**TOWN OF PORTOLA VALLEY  
ARCHITECTURAL AND SITE CONTROL COMMISSION (ASCC)  
Tuesday, August 27, 2013  
Special Field Meetings (time and place as listed herein)  
7:30 PM – Special ASCC Meeting  
Historic Schoolhouse  
765 Portola Road, Portola Valley, CA 94028**

**TO:** ASCC  
**FROM:** Tom Vlastic, Town Planner  
**DATE:** August 27, 2013  
**RE:** Agenda for August 27, 2013 (Tuesday) Special ASCC Meeting  
(Rescheduling of regular Monday August 26, 2013 ASCC meeting.)

GRADING AND DRAINAGE PLAN  
 MARTA RESIDENCE  
 5 NARANJA WAY  
 PORTOLA VALLEY, CA

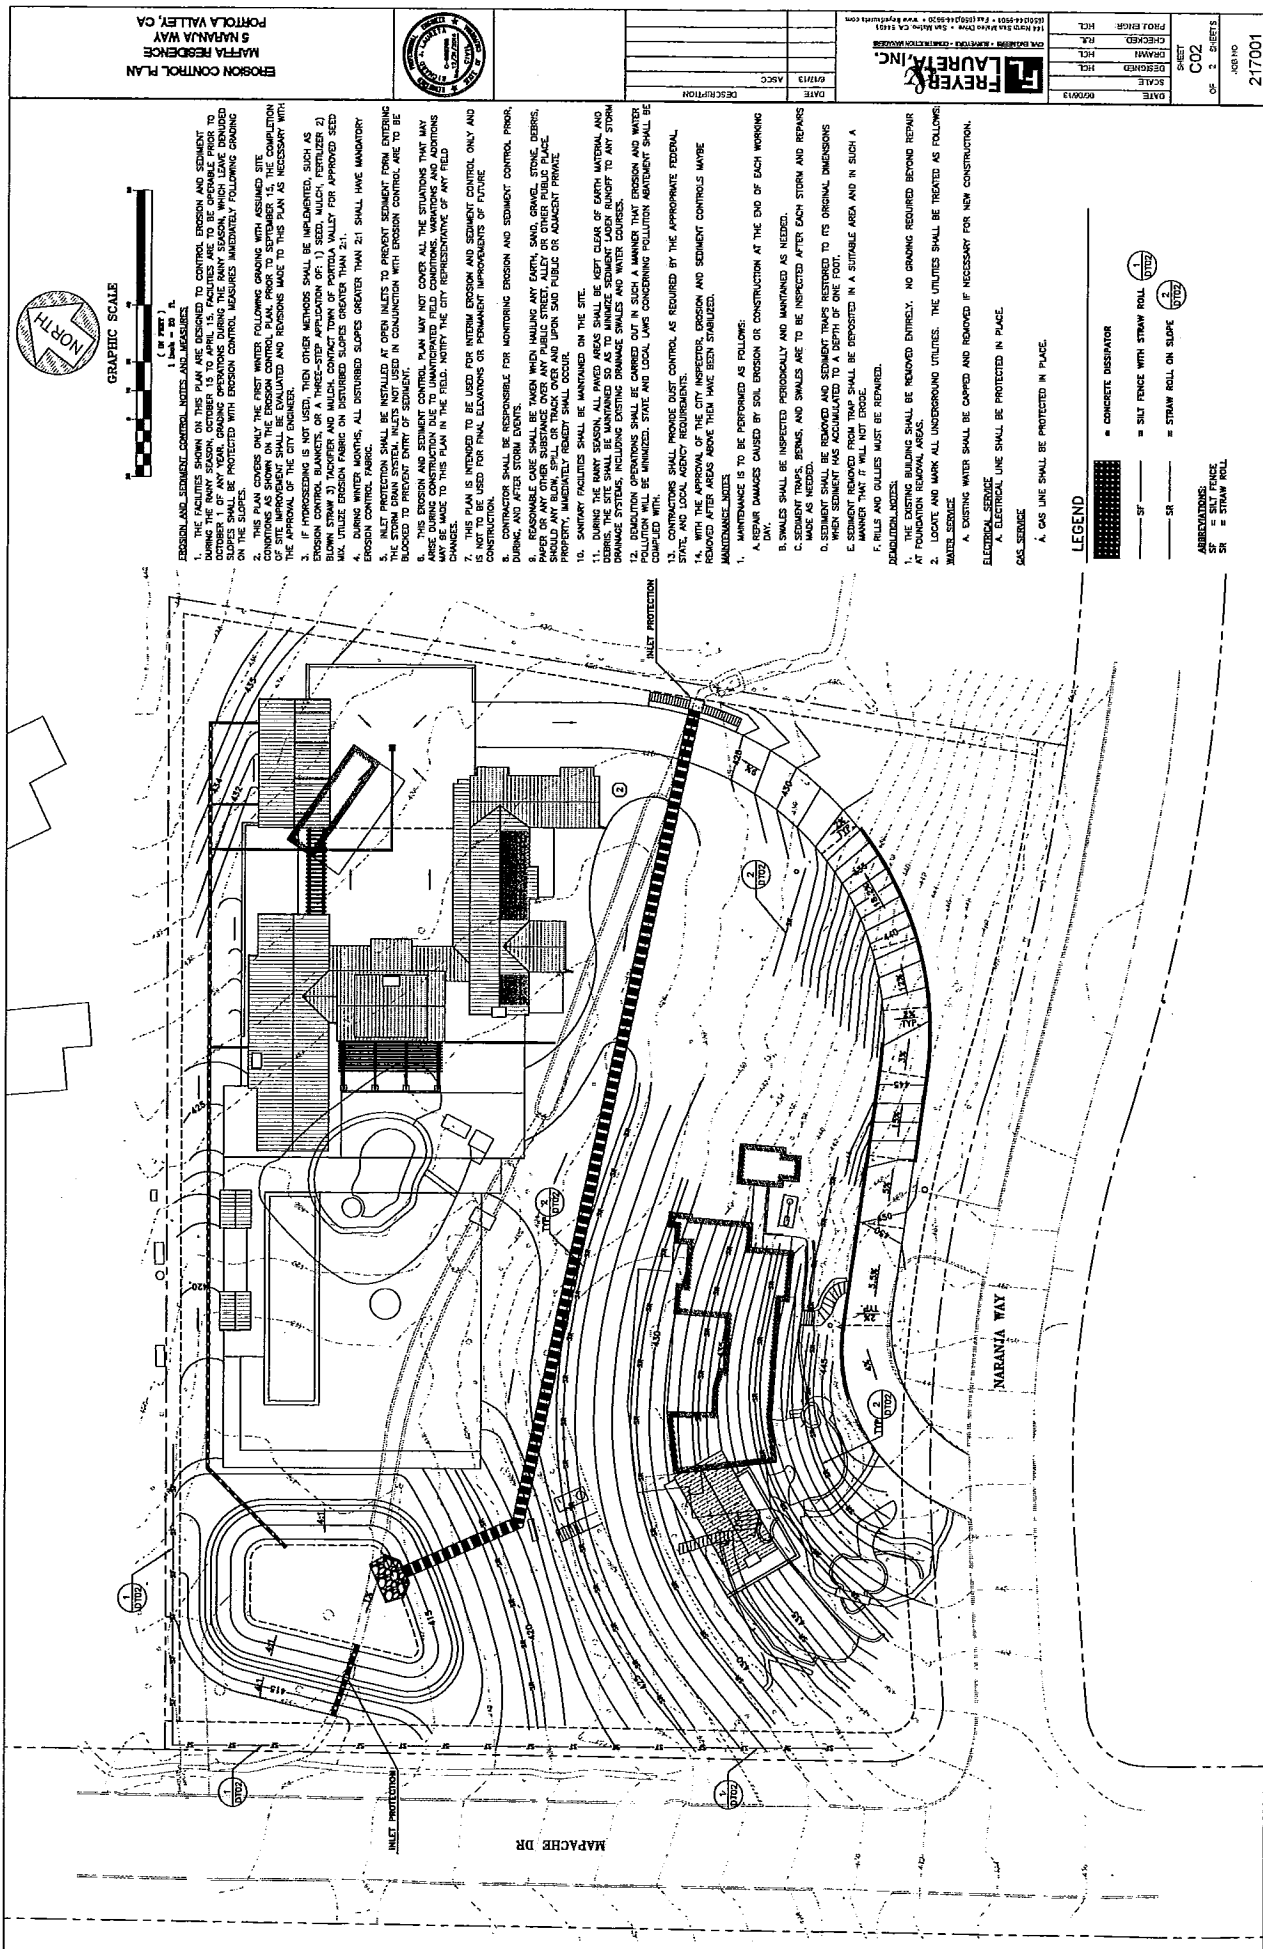
**Sheet C01 – Grading and Drainage Plan:**

3. TS and BS elevations show steps greater than 1.6' but no actual stair steps. Will there be a railing system at these locations?
4. Grading General Note 5 references Detail 4 on sheet DT01 – no detail sheet shown.

LANDSCAPE  
MASTER  
PLAN

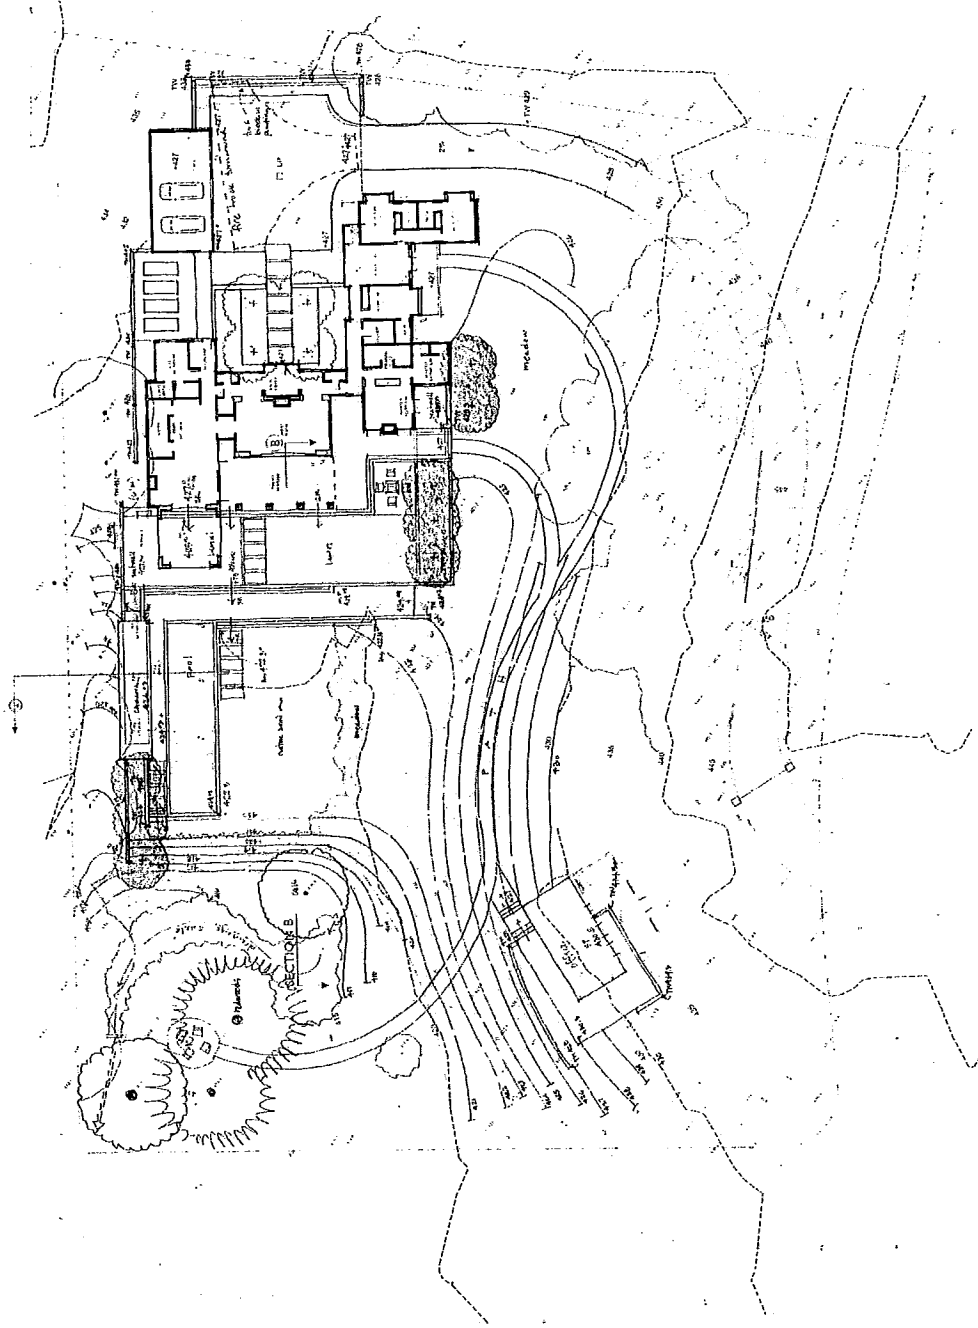
The proposed revised grading is detailed on the 8/19 earthwork calculation sheet and shown in concept on the 8/12/13 Landscape Master Plan. This includes the grading to repair the site of the existing house and the current driveway access and parking apron connected to Mapache Drive. It also includes the fill needed for the elimination of the existing rock lined drainage ditch and swimming pool and to properly convey surface waters across the site.

Overall, our main concern with the grading plan is associated with the fill planned for the pool and west side lawn/native grass terrace. We shared these concerns and others related to the need for plan clarifications and corrections in an 8/21/13 email to the project architect. These email comments and responses from the architect are presented in the attached August 21, 2013 email communications. The comments in the communications will be helpful in preparing for the site meeting.
